Work Order ID 93021

Item Name: Replacement Skidtube STD w/ Training Wearplates

DRAWING NO. D3887	TITLE A119 STD SKIDTUBE ASSY	REV. B	DART AEROSPACE LTD ENGINEERING ORDER		D.E.O. NO. D3887-B-1	SHEET NO. SHEET 1 OF 1	SCALE NTS
DRAWN AJS	CHECKED <i>qp</i>	MFG. APPR. <i>qp</i>	APPROVED <i>[Signature]</i>		DE APPR. <i>[Signature]</i>		
DATE 12.10.29	DATE 12.10.29	DATE 12.10.30	DATE 12.10.30		DATE 12.10.30

MODIFICATION OF EXISTING DESIGN TO ALLOW INSTALLATION OF CROSSBOLT SPACERS FOR FORWARD GROUND HANDLING EQUIPMENT.

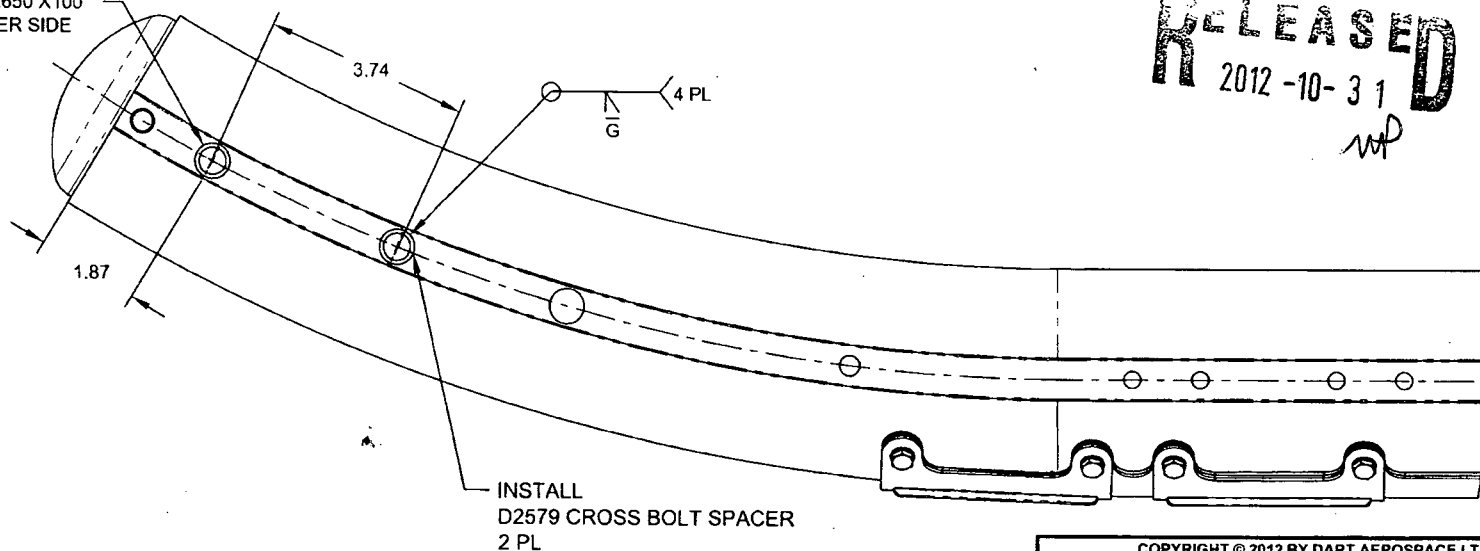
ADD THE DRILLING DETAIL BELOW TO DRILLING INFORMATION (SHEETS 5 & 6):

ADD CROSSBOLT SPACER INSTALLATION INFORMATION TO -041 THRU -045 (SHEETS 2 - 4):

DRILL Ø0.500 THRU
CSK Ø0.650 X100°
2 PL PER SIDE

FIGURE 1. MODIFIED D119-646-XXX SKIDTUBE

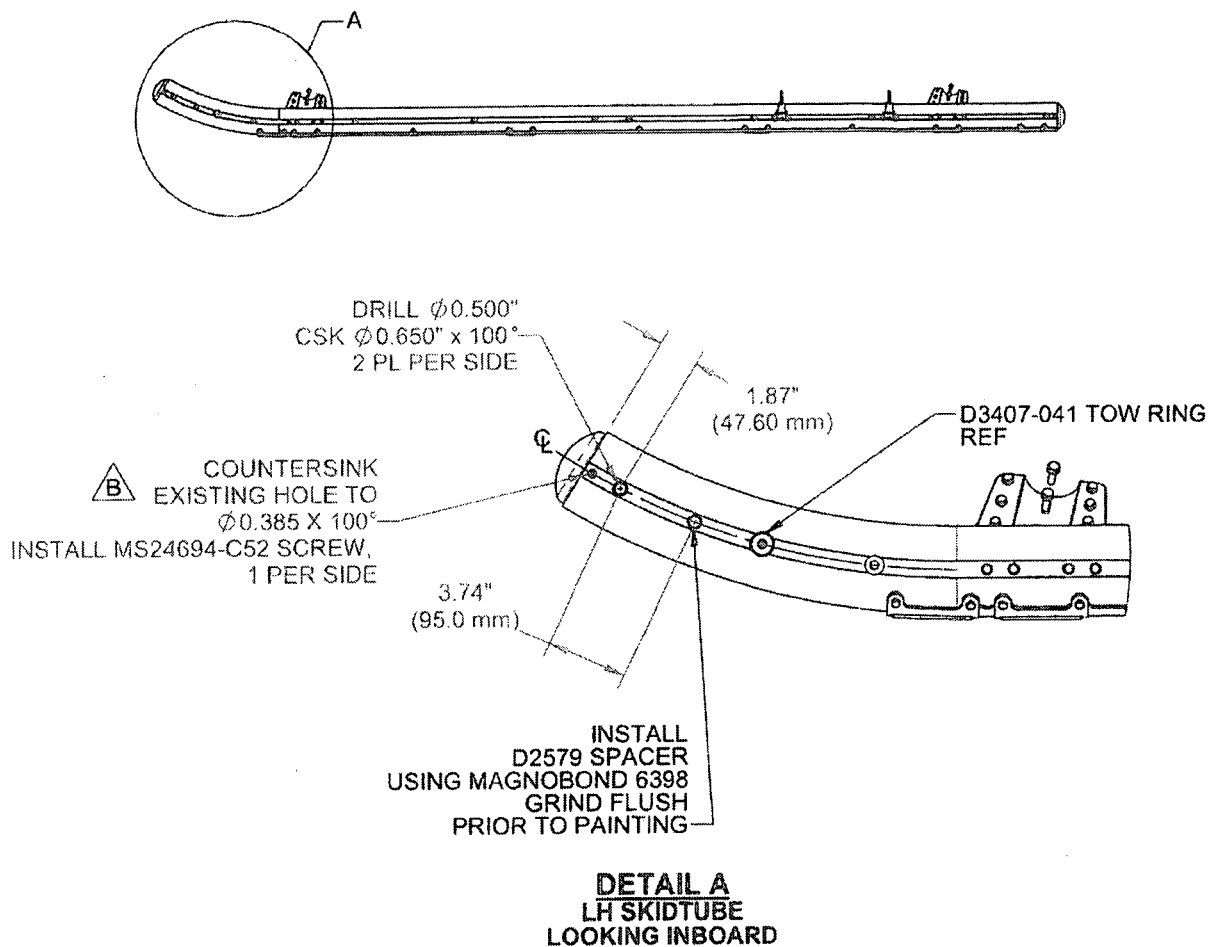
The purpose of this DSI is to provide instructions for customers to modify the forward end of the D119-646-XXX skid tubes using the DSI 9594-011 Kit to make the skid tubes compatible with the Agusta ground handling wheels. One kit modifies 2 skid tubes. After CHG 001, portions of this modification may have been incorporated in production and therefore will not need to be incorporated in the field.

B	ADD INSTRUCTION TO REMOVE EXISTING CAP MOUNTING HARDWARE AND REPLACE WITH COUNTERSUNK SCREWS	DB	13.02.20
A	NEW ISSUE	RF	12.02.03
REV.	DESCRIPTION	BY	DATE
DESIGN	RF	DART AEROSPACE USA, INC. KENT, WA	
DRAWN	DB		
CHECKED	MB	DRAWING NO.	REV. B
MFG. APPR.	N/A	DSI 9594	SHEET 1 OF 2
APPROVED		TITLE	SCALE
DE APPR.		FWD GROUND HANDLING SPACER KIT	NTS
DATE	13.02.20	<small>COPYRIGHT © 2012 BY DART AEROSPACE USA, INC. THIS DOCUMENT IS PRIVATE AND CONFIDENTIAL AND IS SUPPLIED ON THE EXPRESS CONDITION THAT IT IS NOT TO BE USED FOR ANY PURPOSE OR COPIED OR COMMUNICATED TO ANY OTHER PERSON WITHOUT WRITTEN PERMISSION FROM DART AEROSPACE USA, INC.</small>

- 2.1 Rotate the D3407-041 Tow Ring to the vertical position as necessary.
- 2.2 Mark holes in the center ridge as shown in Figure 1. Drill through skid tube with $\varnothing 0.500"$ (12.7 mm drill), and countersunk to $\varnothing 0.650 \times 100^\circ$, two places per side.

- 2.3 Remove and discard the hardware retaining the forward Cap. Countersink the existing holes to $\varnothing 0.385 \times 100^\circ$.
- 2.4 Deburr holes. Touch up affected areas with chemical film material (Alodine 1200 or 1201) per MIL-C-5541.

- 2.5 Bond D2579 spacers into the $\varnothing 0.500$ holes center in the skid tube using Magnobond 6398. Grind flush prior painting as shown in Figure 1.
